SPRINGS AT WATERVIEW
DRAINAGE LETTER
EL PASO COUNTY, COLORADO

July 2019

PCD No. SP-16-005
PCD No. SF-16-017

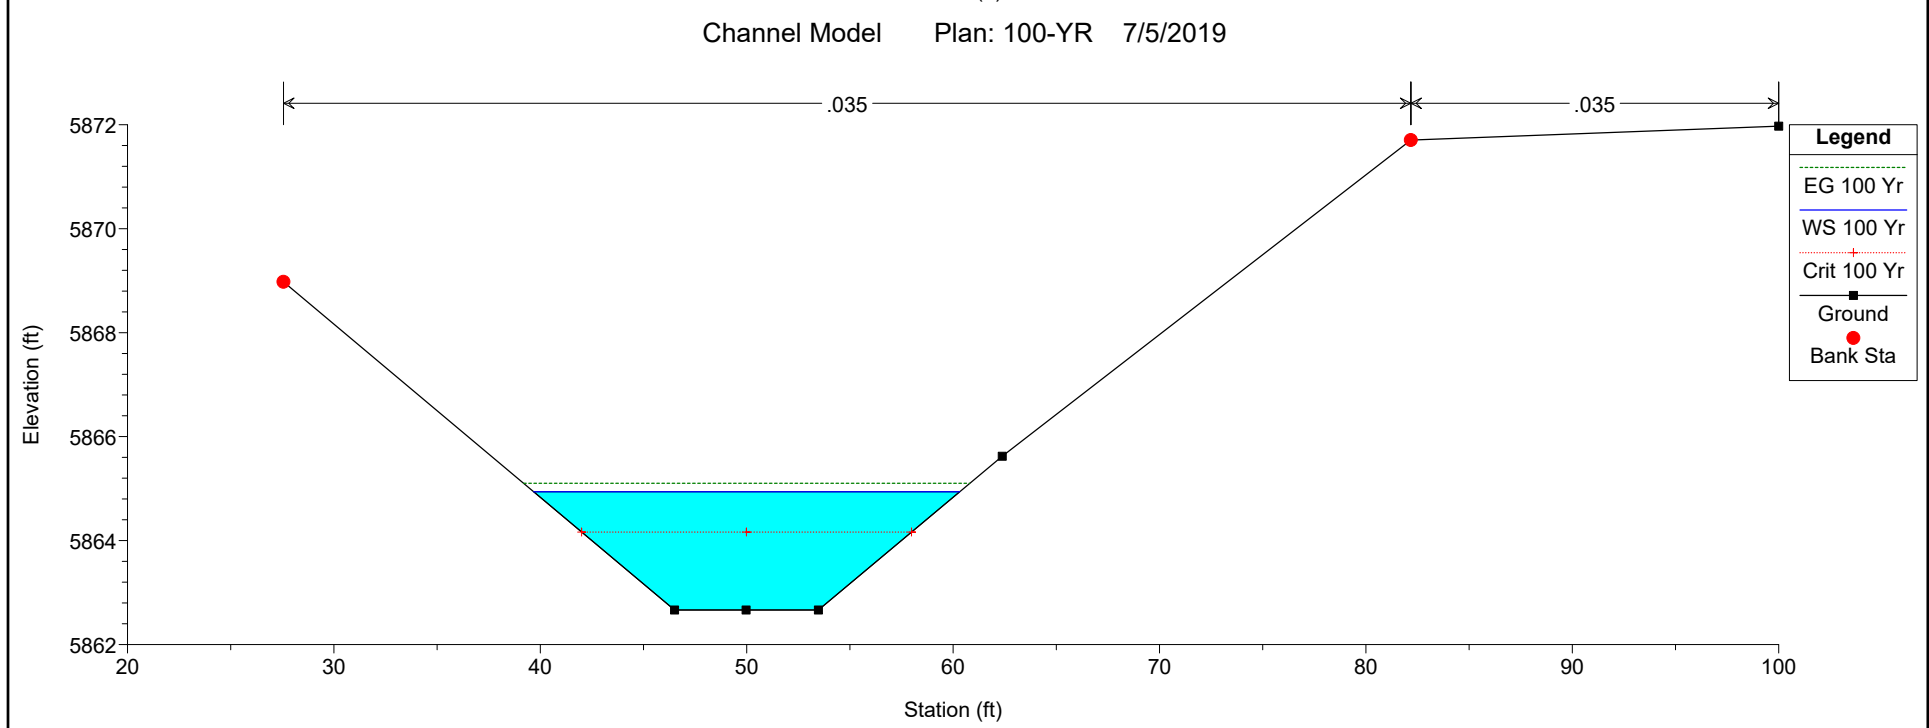
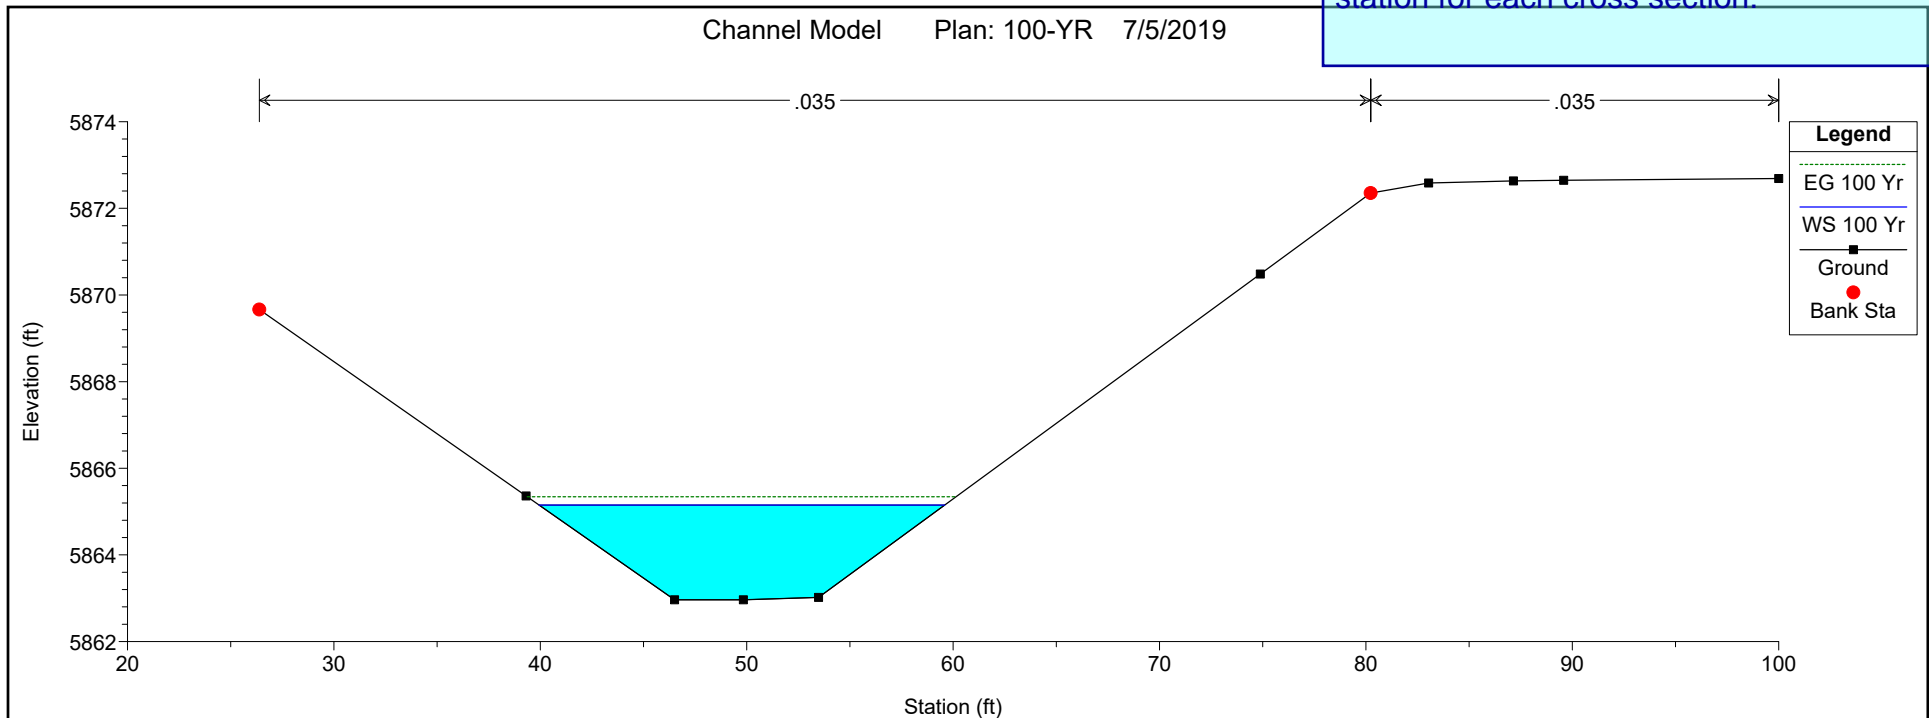
All values on the Qtotal does not match the previous report.

Examples: The approved FDR showed the following flows at the following river station:

- South ditch station 750 = 24.1 cfs (DP K)
- South ditch station 000 is equivalent to FDR Stormcad pipe P-19 which shows 148 cfs
- East Ditch station 028 is equivalent to FDR Stormcad pip P-18 which shows Q = 130 cfs

Channel Model Plan: 100-YR 7/5/2019

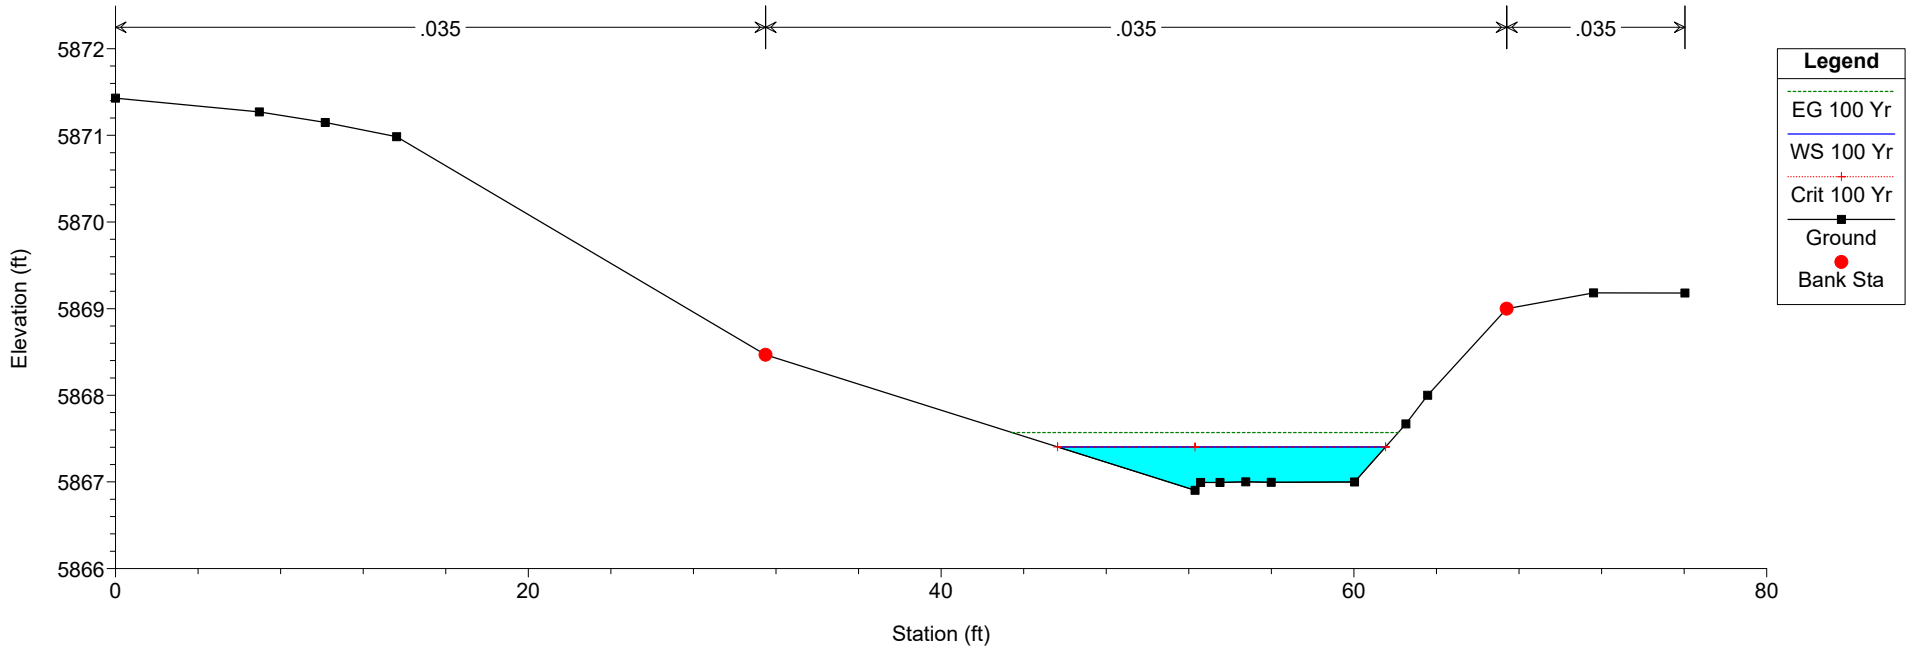
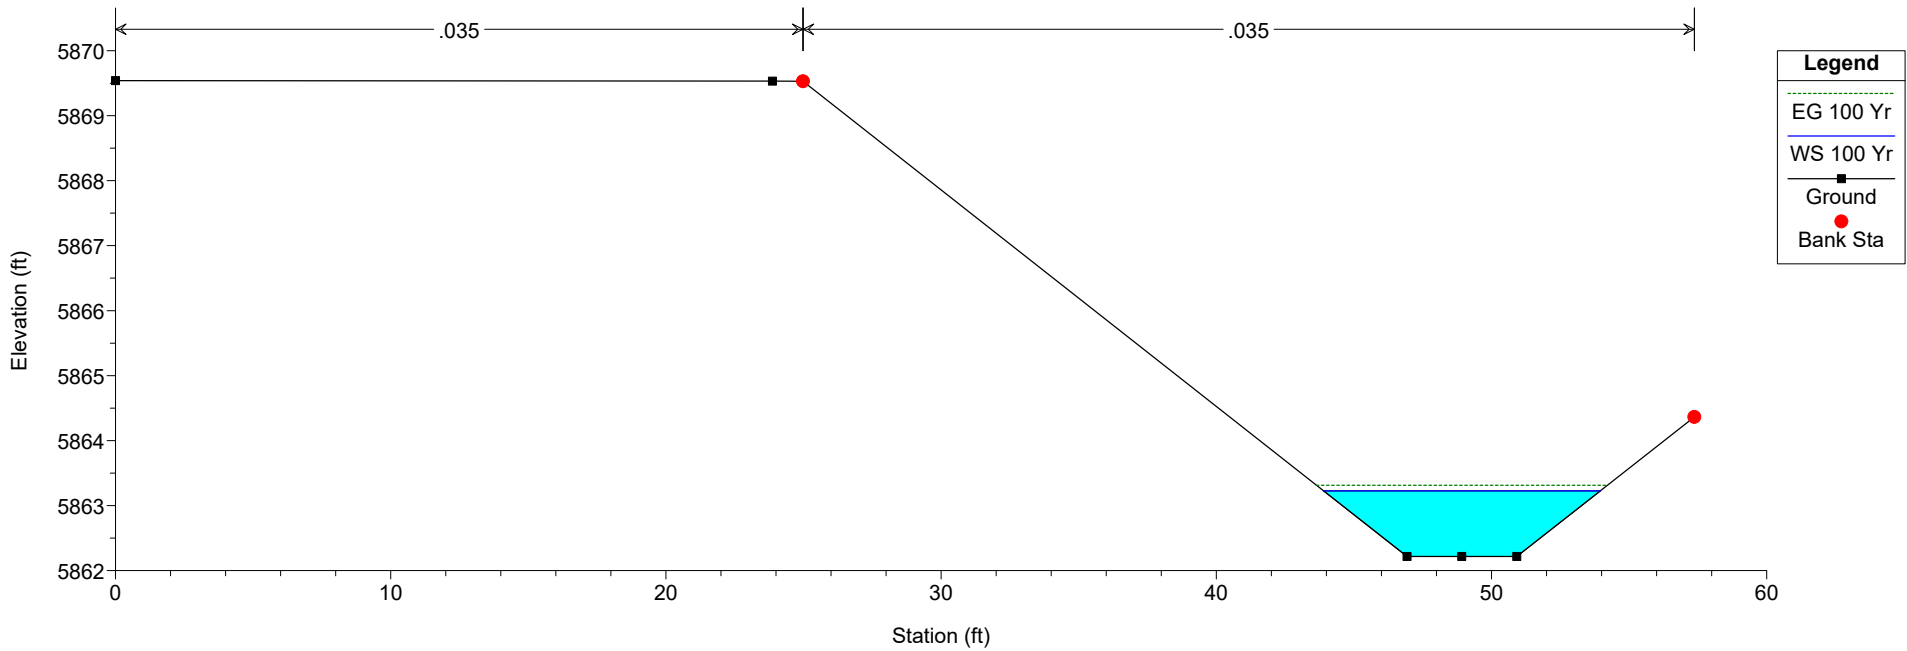
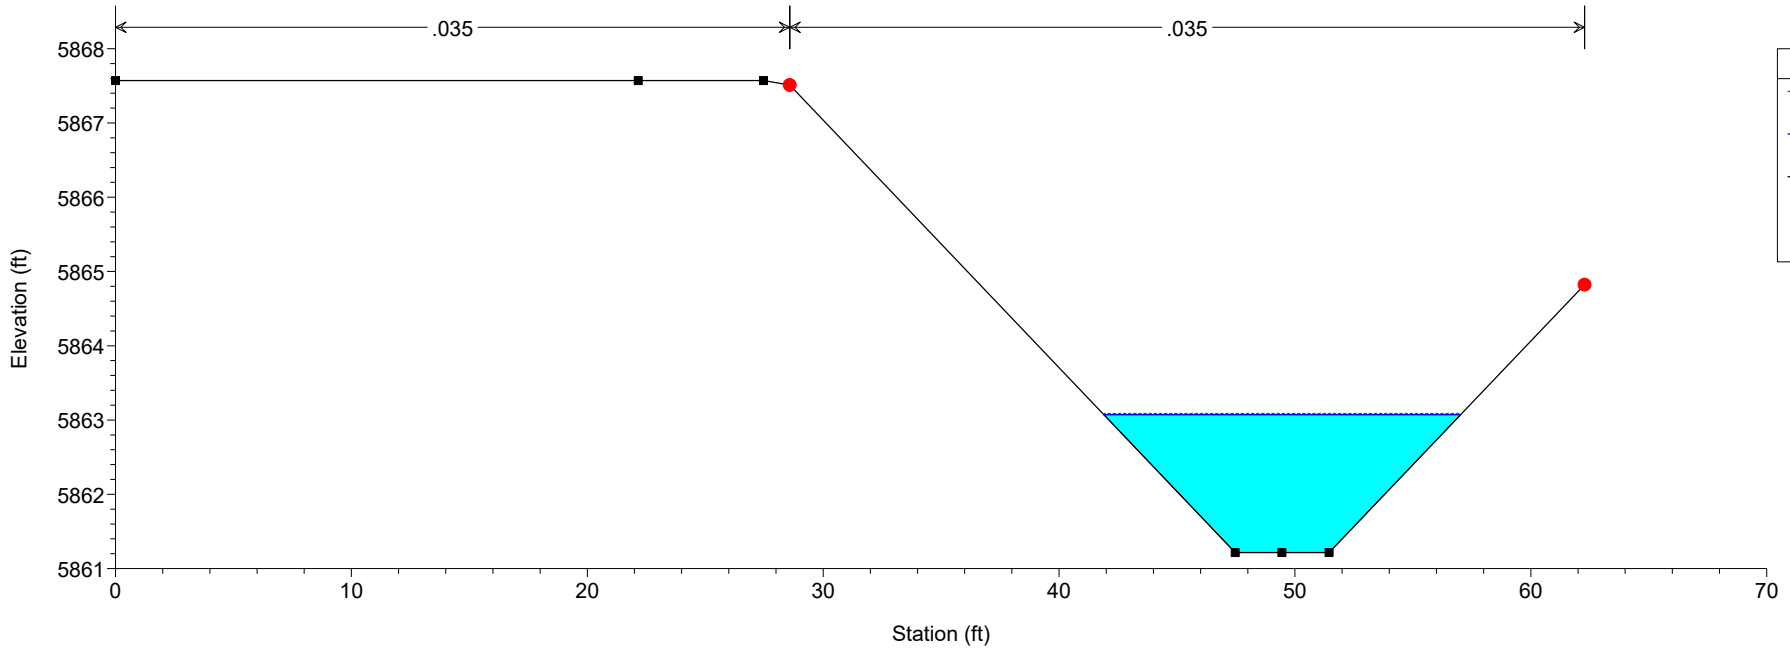
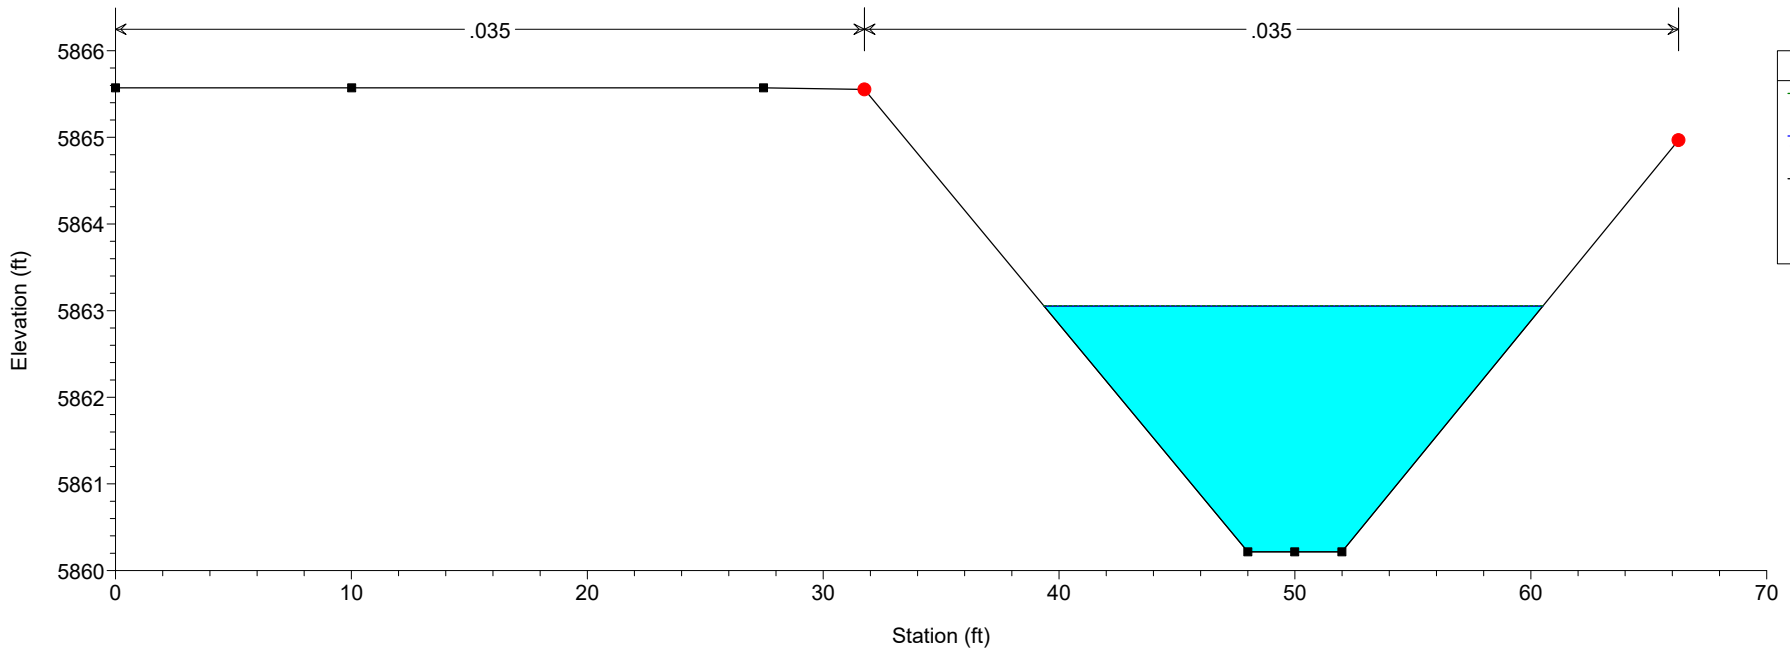
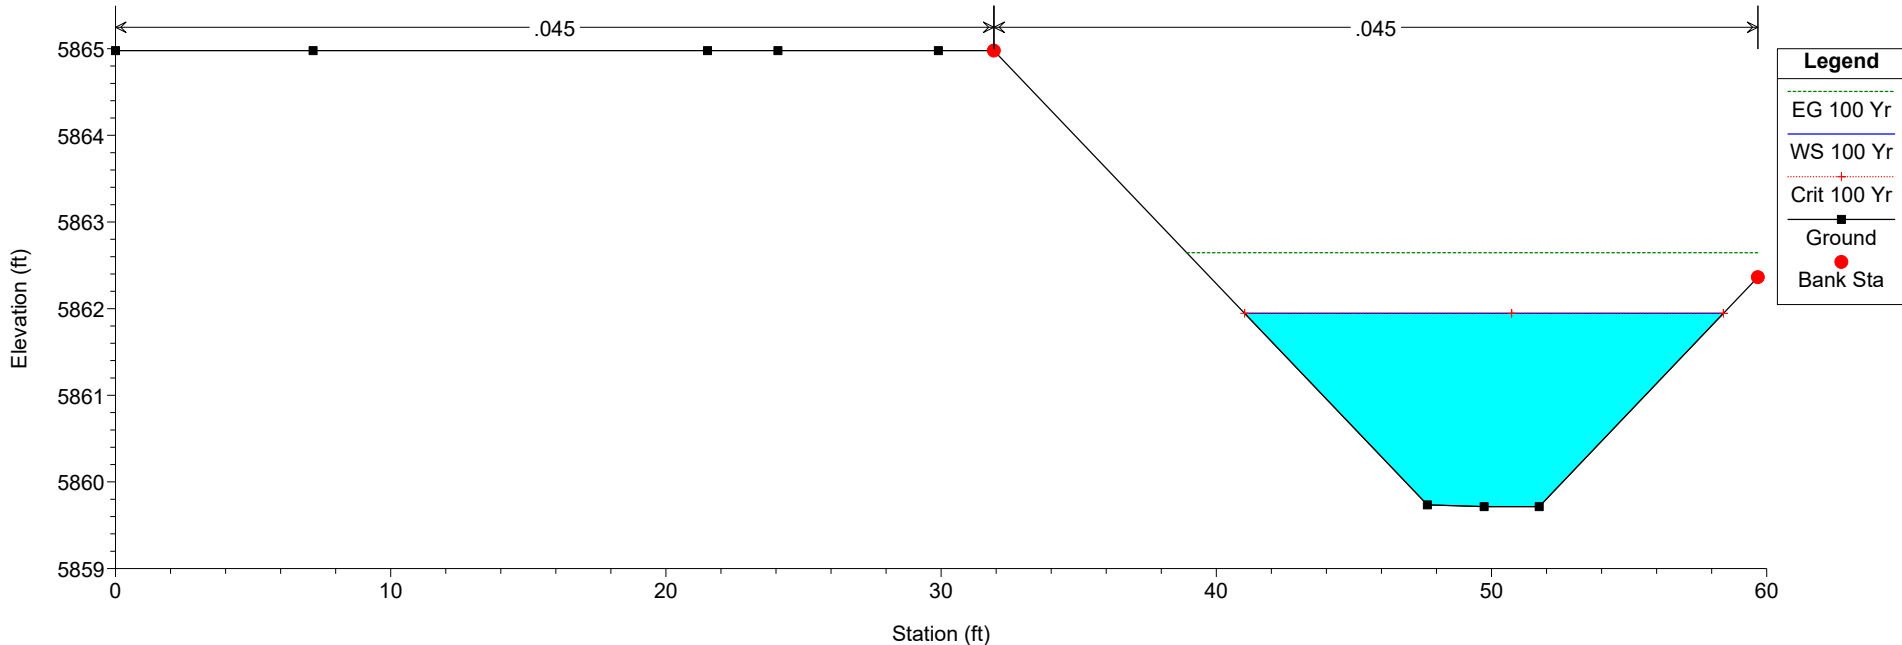
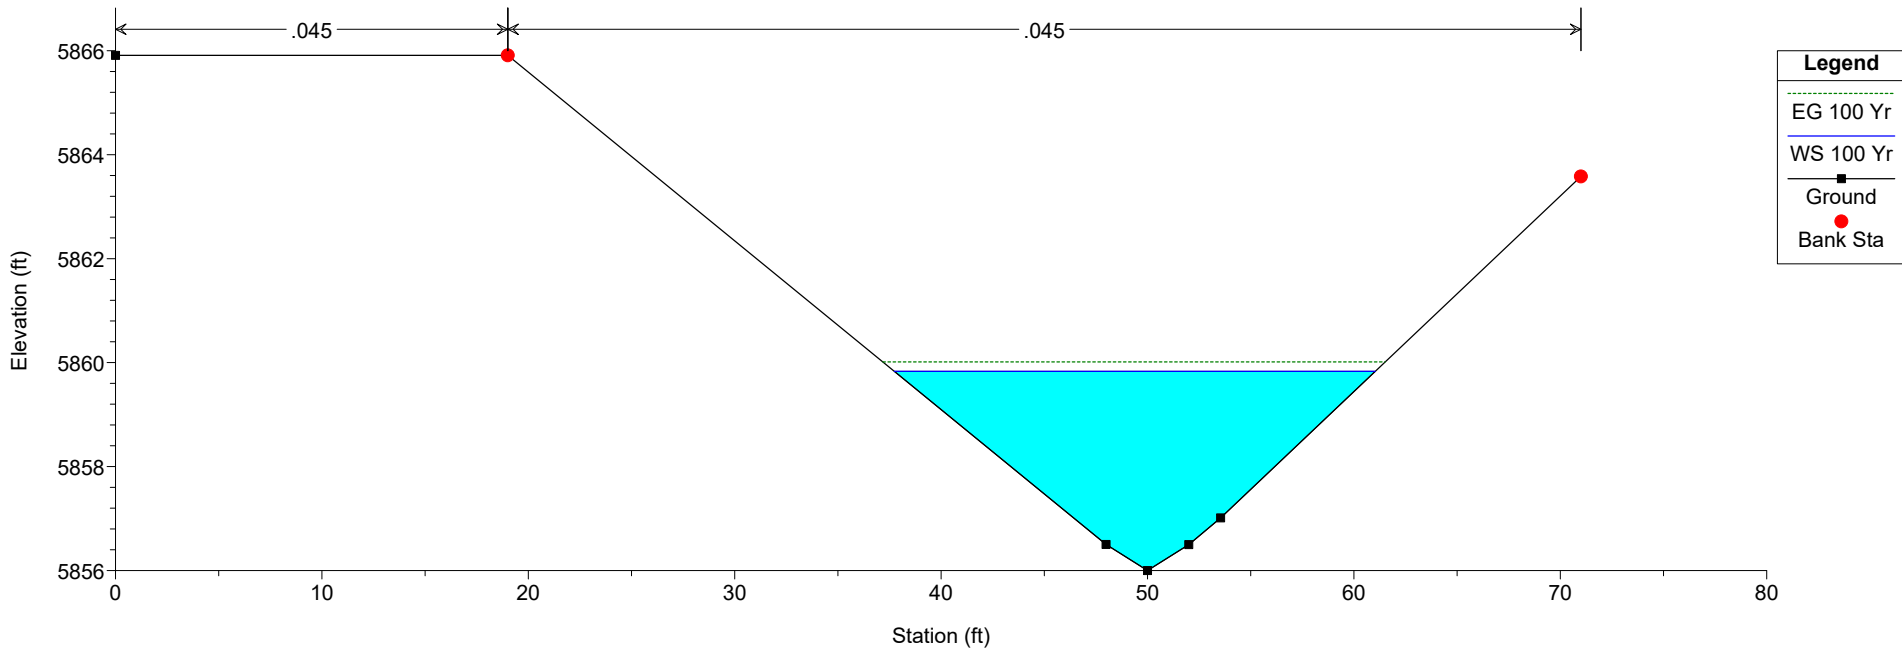
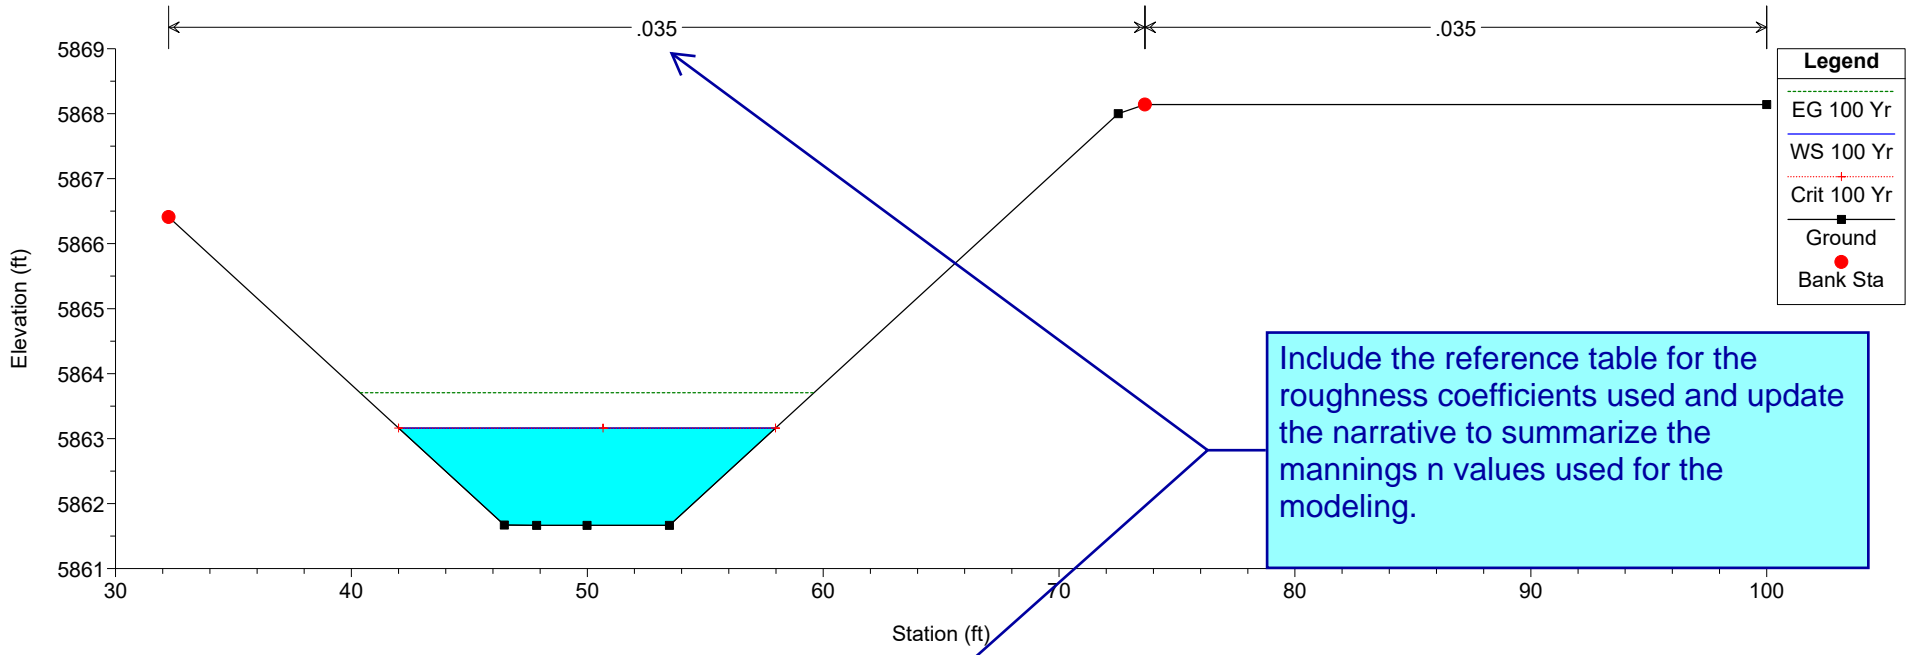
Identify the corresponding reach and station for each cross section.
